CITY OF ALBUQUERQUE

Re: Reflective Auto Collision
801 Gibson Blvd. SE
30-Day Temporary Certificate of Occupancy
Transportation Development Final Inspection
Engineer's Stamp dated 09-02-22 (L14-D061)
Certification dated 01-23-2025

A PROPOSED PLAN FOR REFLECTIVE AUTO COLLISION
801 GIBSON BOULEVARD S.E.
ALBUQUERQUE, NEW MEXICO

TRAFFIC CIRCULATION LAYOUT
"ENGINEER'S CERTIFICATION"

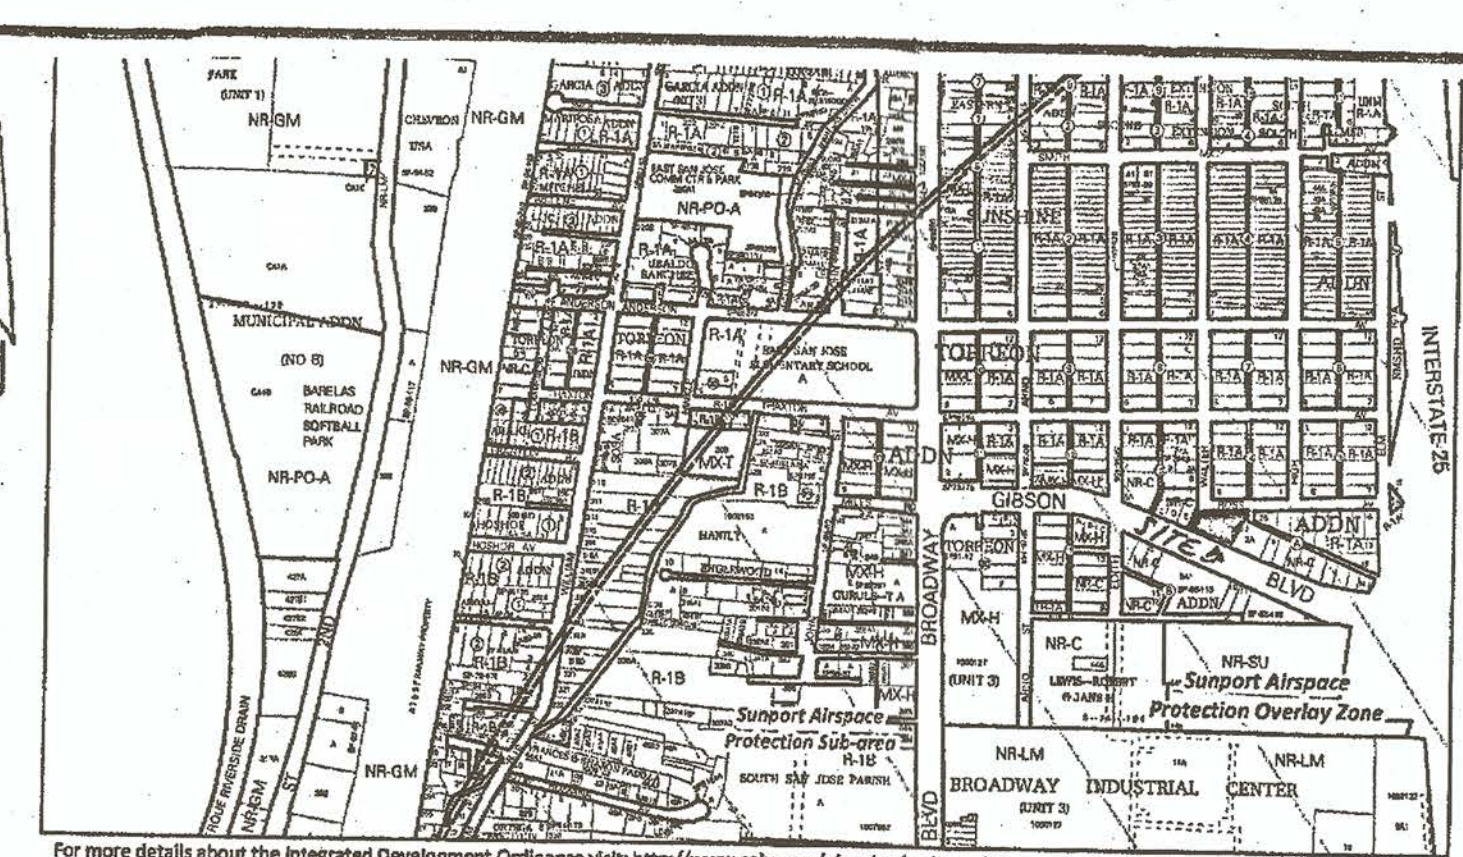
1. The ADA accessible parking sign must have the required language per 66-7-352.4C NMSA 1978 **"Violators Are Subject to a Fine and/or Towing."** Please call out detail and location of signs.
2. Anchor down bike rack.
3. Per approved site plan, a truncated domes must be installed at the site accesses ramps within the city right of way.
